ADDENDUM #2

TO CONTRACT DOCUMENTS FOR: Project #CP245321 – Patient Care Tower – T1230 MRI Room

PREPARED FOR: The Curators of the University of Missouri

17 FIRST FLOOR - DEMOLITION FLOOR PLAN
1/8" = 1'-0"

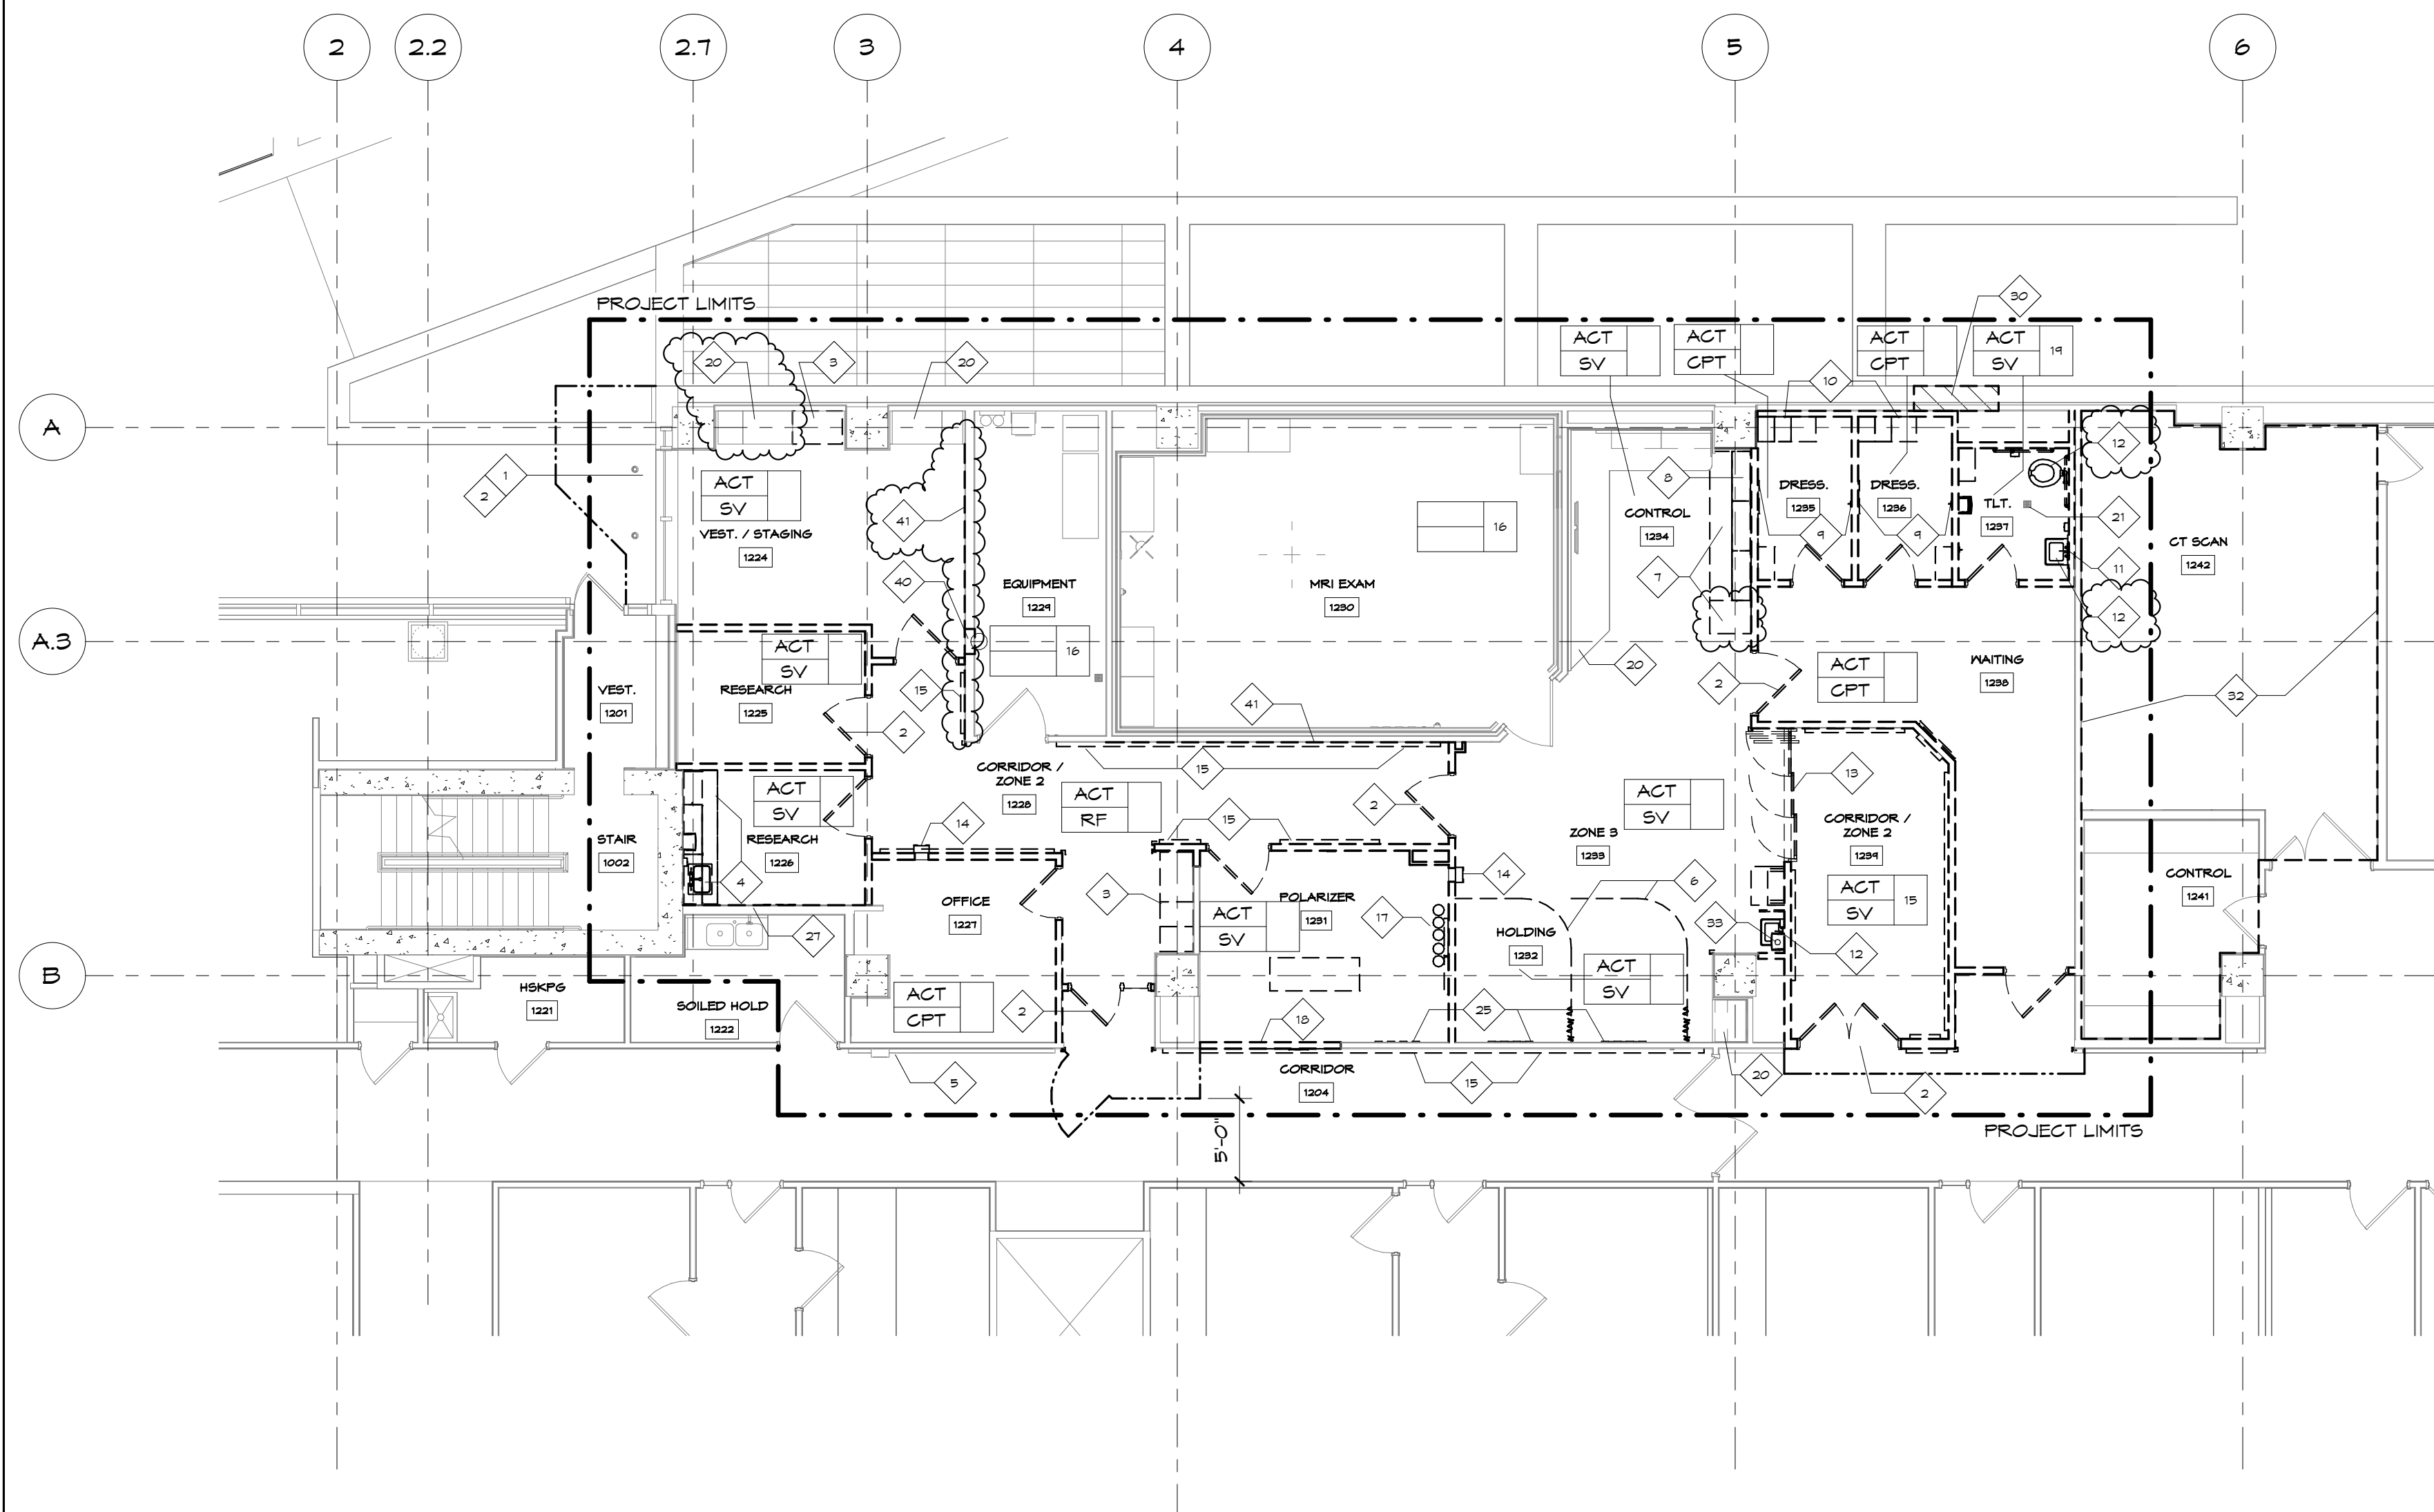
- 1) AD2.1 – First Floor – Demolition Plan & Notes
 - a. Plan 17 – First Floor – Demolition Plan, **REVISE** scope of casework removal and salvage to show portion of casework at north wall of existing Vestibule / Staging area to remain, per attached drawing. **ADD** section of casework and note for casework to be salvaged at east wall of existing Control Room. **ADD** note and scope for removal of drywall along east wall of existing Vestibule / Staging area for installation of new metal backing.
 - b. **MODIFIED** Keyed Notes 10, 11, 12, and 41 as per the attached drawings.

25 FIRST FLOOR PLAN - NEW WORK
1/4" = 1'-0"

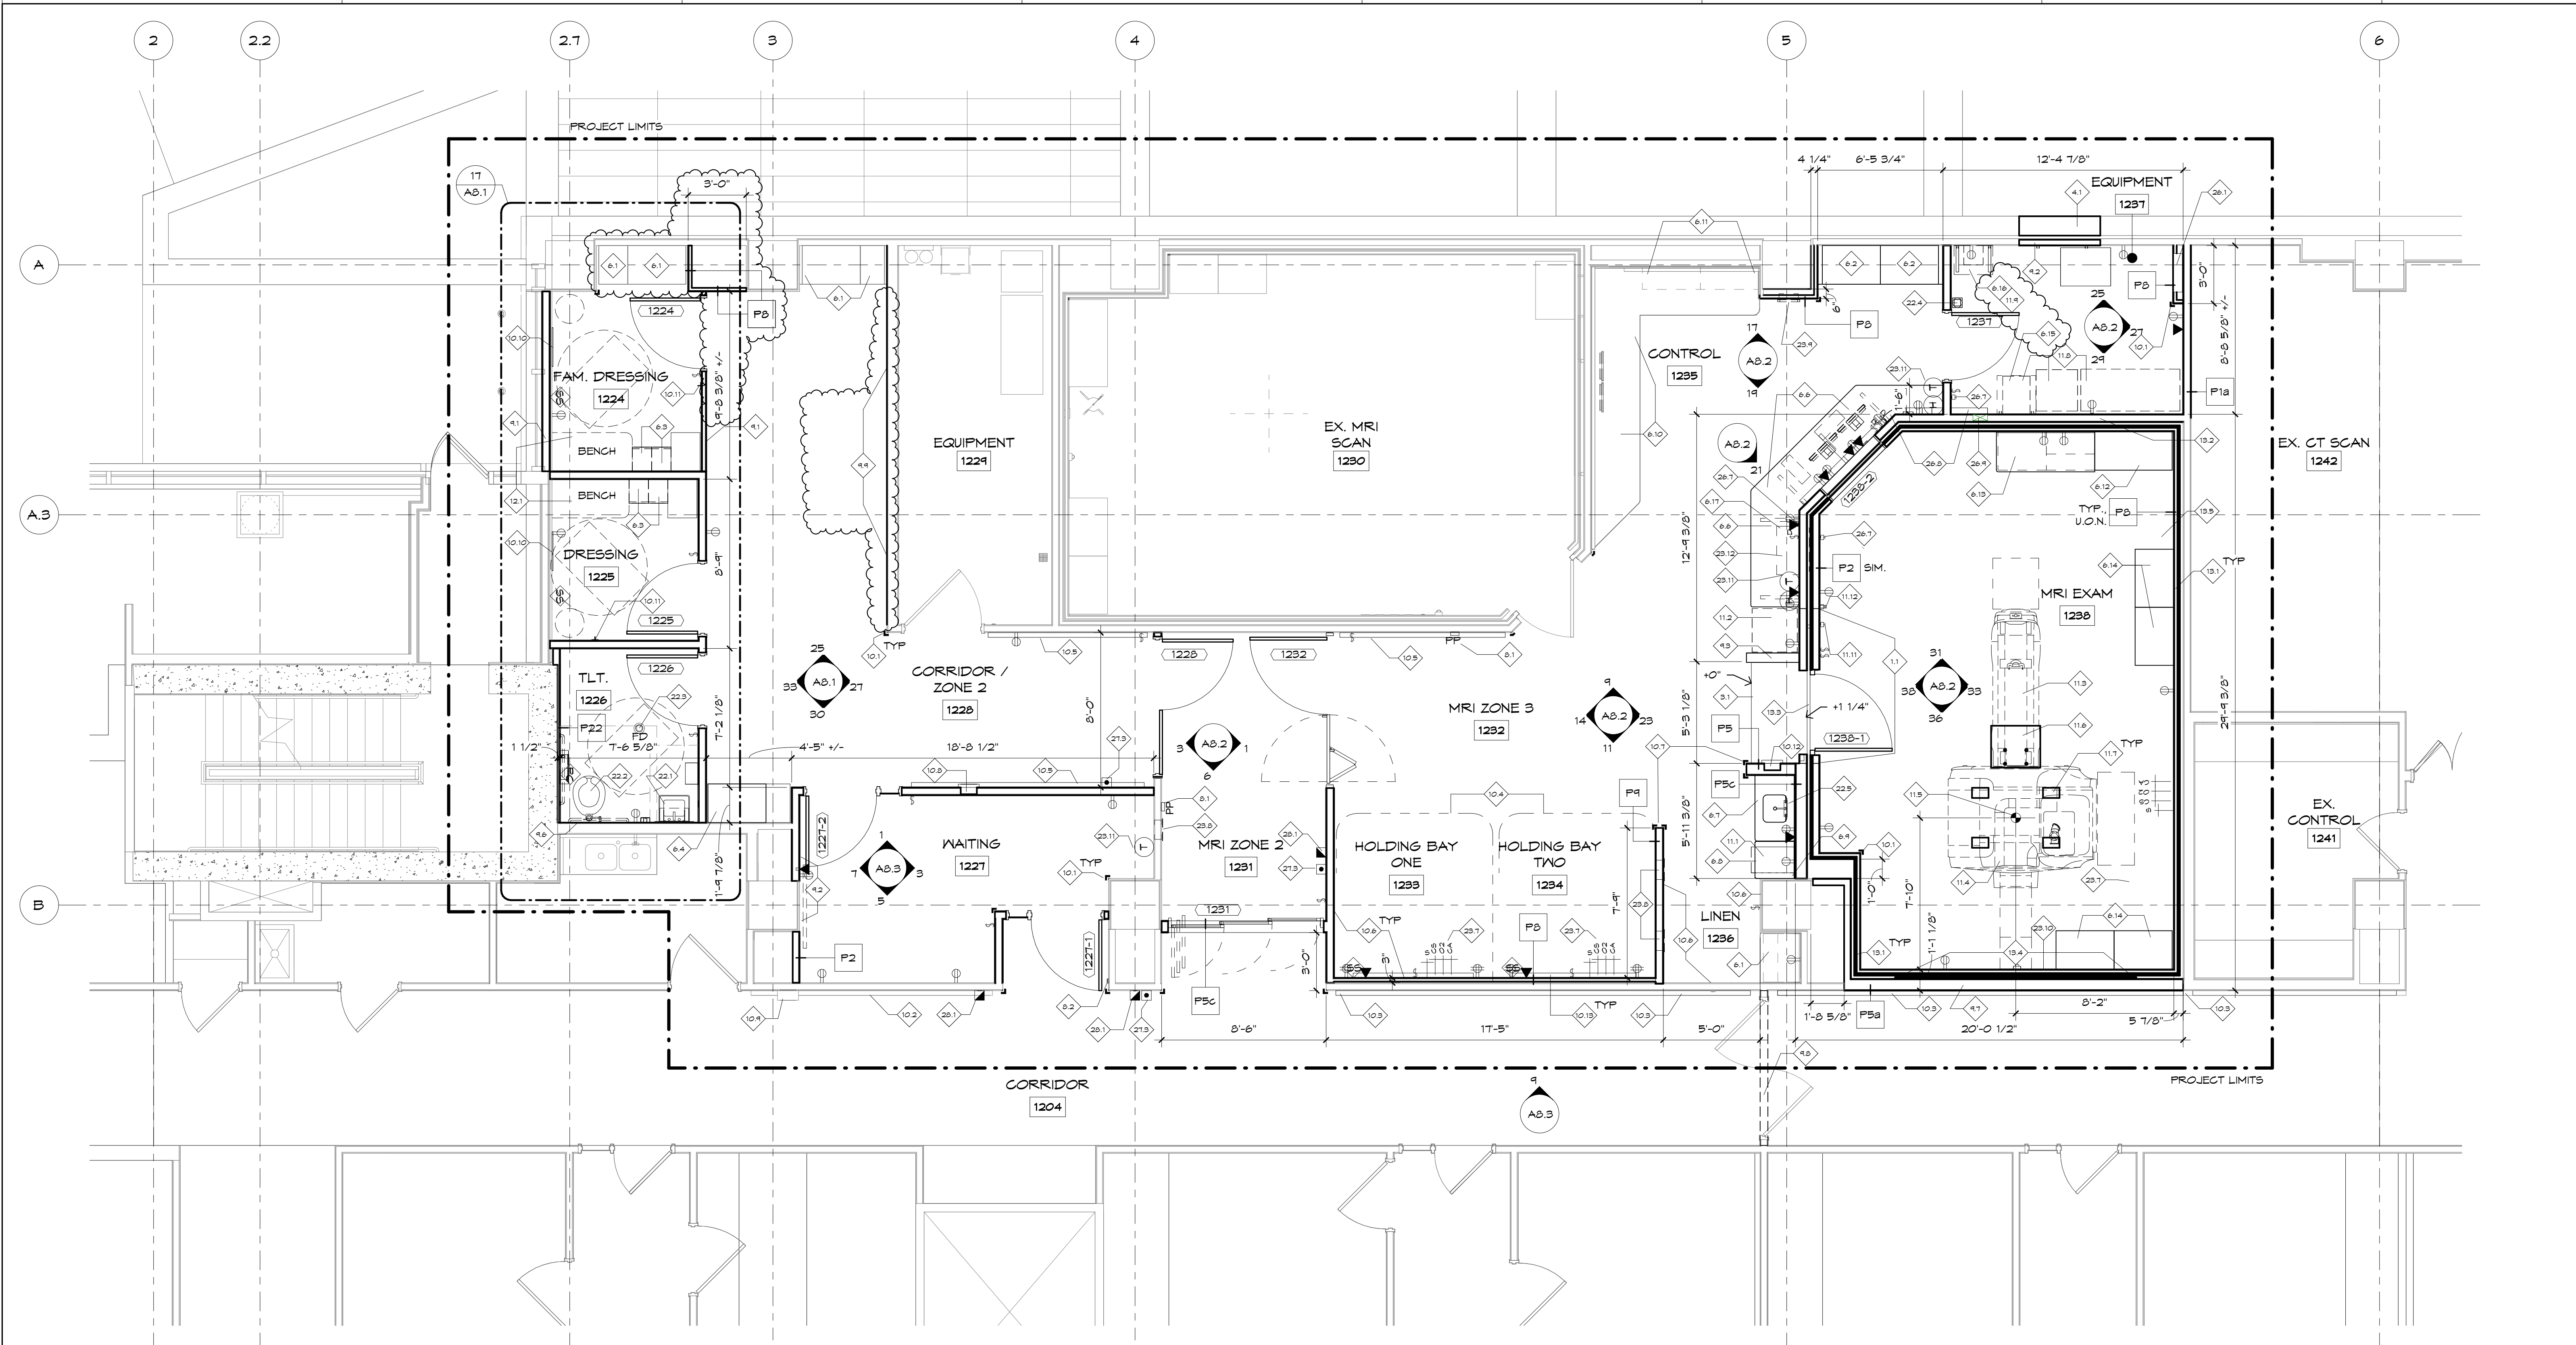
- 2) A2.1 – First Floor – New Work Floor Plan & Notes
 - a. Plan 25 – First Floor Plan – New Work, **ADDED** metal stud partition chase at north of Family Dressing / Corridor Zone 2. **REMOVED** casework at north and east walls of Corridor Zone 2. **ADDED** scope and keyed note (9.9) calling for installation of metal backing in existing east wall of Corridor Zone 2.
 - b. **MODIFIED** Keyed Notes 3.1, 4.1, 6.17, 10.10 and 11.9 as per the attached drawing.
